DEVELOPMENT ASSESSMENT REPORT	
Application No.	DA/2023/0046
Address	72 Johnston Street ANNANDALE
Proposal	Proposed demolition of existing buildings, construction of two detached dwellings, rear studios, inground swimming pools, associated boundary fencing, new vehicle crossing, tree removal and Torrens Title subdivision into 2 lots.
Date of Lodgement	01 February 2023
Applicant	Metric Interiors & Projects Pty Ltd
Owner	Met Plus Group Pty Ltd
Number of Submissions	Initial: Nine (9)
Value of works	\$1,244,650.00
Reason for determination at Planning Panel	<ul style="list-style-type: none"> Departure with development standards variation exceeds 10%
Main Issues	<ul style="list-style-type: none"> Departure from FSR, Landscaped Area and Site Coverage Development standards Heritage conservation Johnston Street distinctive neighbourhood character Building siting and location (building envelope, building location zone, side setbacks) Tree management and protection Stormwater management Front gardens, dwelling entries and safety by design Materials and finishes Parking and vehicle access from Johnston Street Inadequate information (Clause 4.6, detailed survey, shadow diagrams, elevation plans)

Figure 9 – Standing view from rear yard

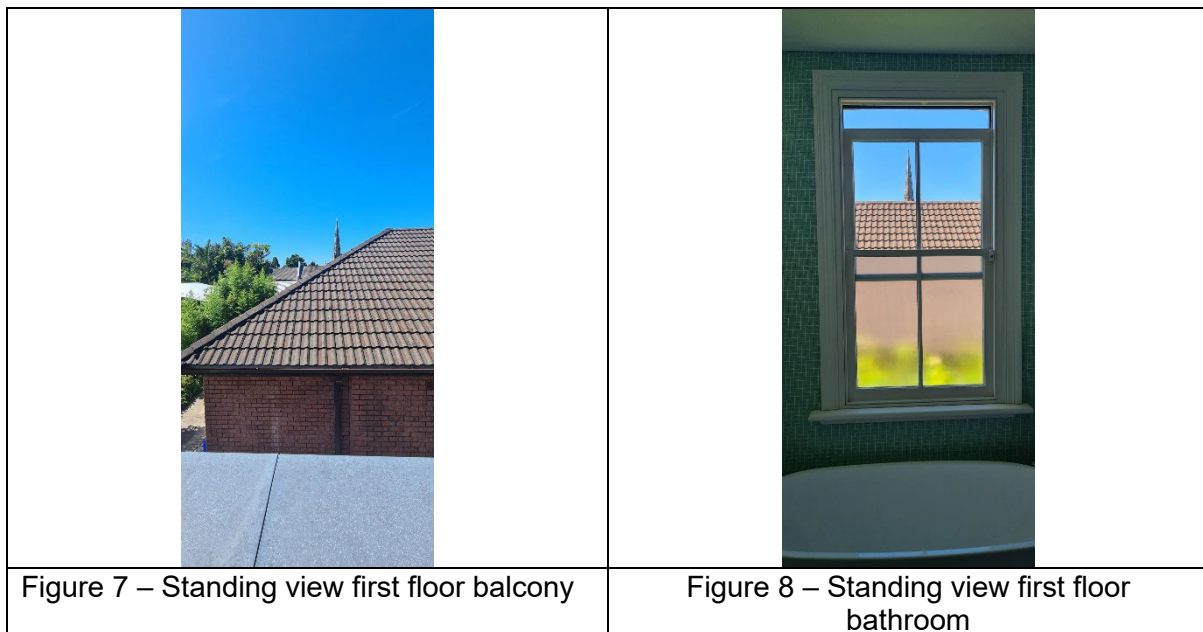
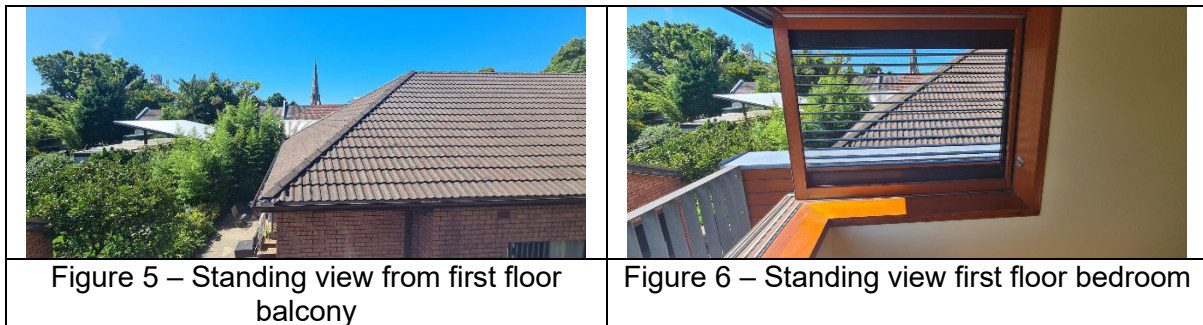
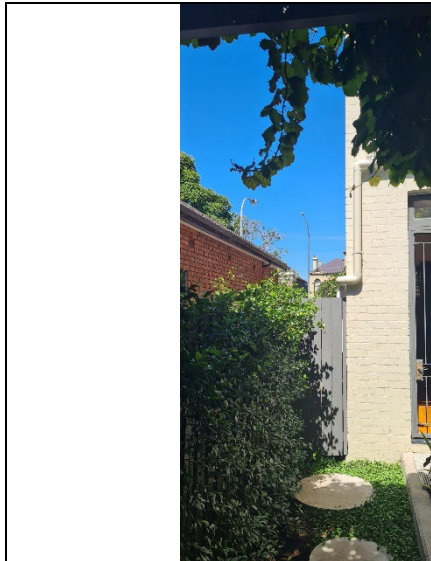
When considering the value of these views, it is considered the views are not highly valuable as the views are not water views and are not whole views of these buildings. The existing dwelling house at No. 72 Johnston Street obstructs most of the view of the Hunter Baillie with the steeple being the only visible building element (figure 5, 6, 7 & 8) and the view of No. 35 Johnston Street is obtained via outlook from the side passage and courtyard (figure 9 and 10).

The views from No 70 Johnston Street rely on an aspect looking primarily across the side boundary of No. 72 Johnston Street (see figure 11). The views are generally enjoyed from a standing position. Views can also be seen from a seated position at the first floor level.

Following an assessment of the development against the planning principle, the overall impacts on the view of the adjoining property (No. 70 Johnston Street) is found to be minor and reasonable.

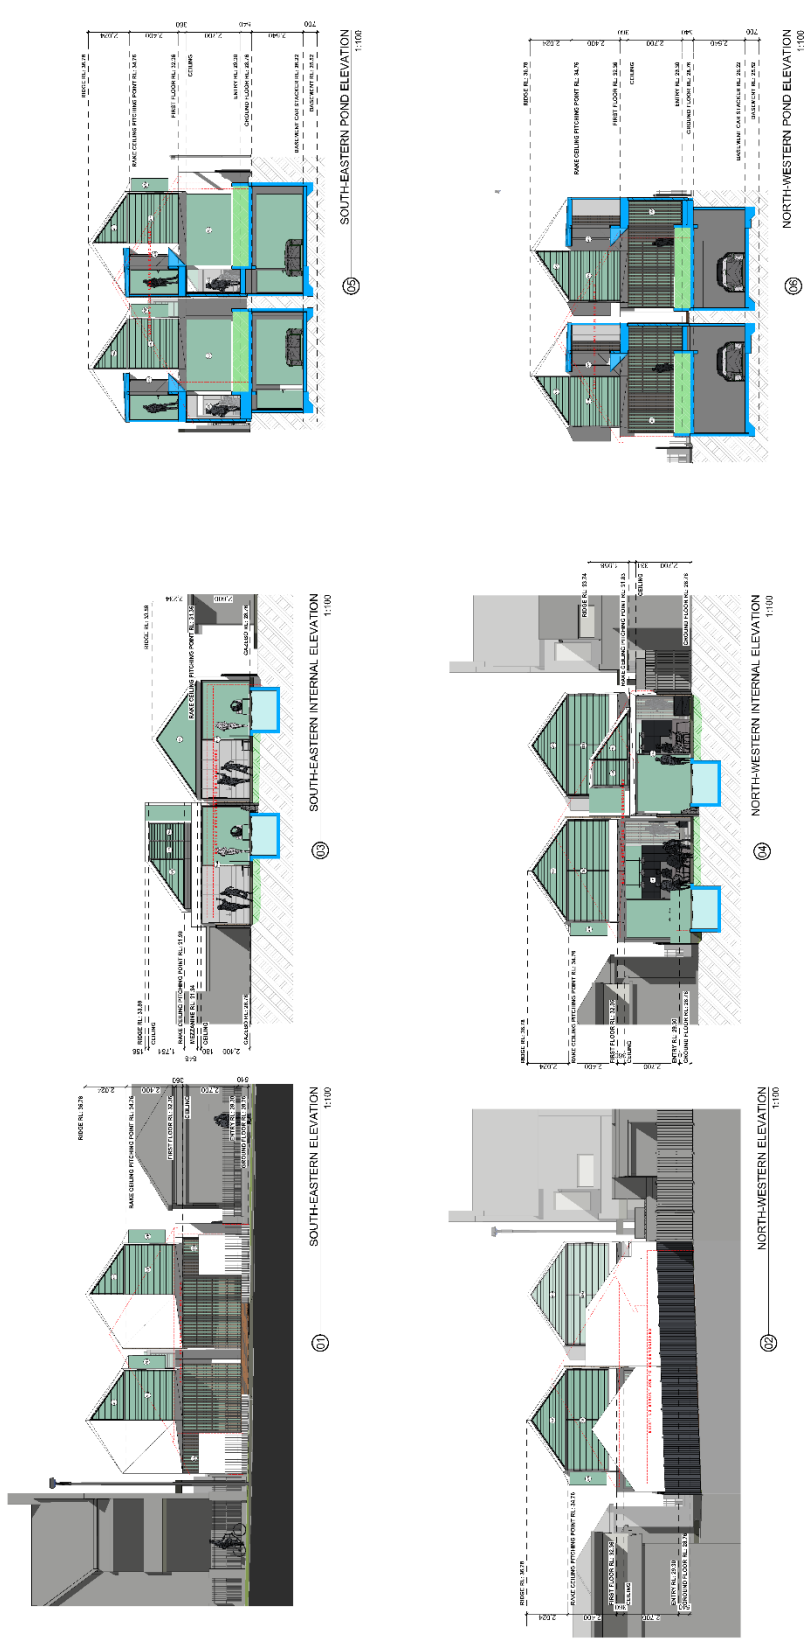
- The fin detail surrounding the gable ends to the south-eastern elevation to both dwellings is not supported as this is not a complementary detail to characteristic dwellings in the streetscape or the HCA.

The south-eastern (front) elevation and 3D perspectives show a modern interpretation of a palisade front fence. This is not supported in respect to the front palisade fences of the adjoining properties. The proposed front fence is not compatible or sympathetic to fences in the streetscape. Accordingly, the removal of the existing iron palisade fence to the front is not supported.
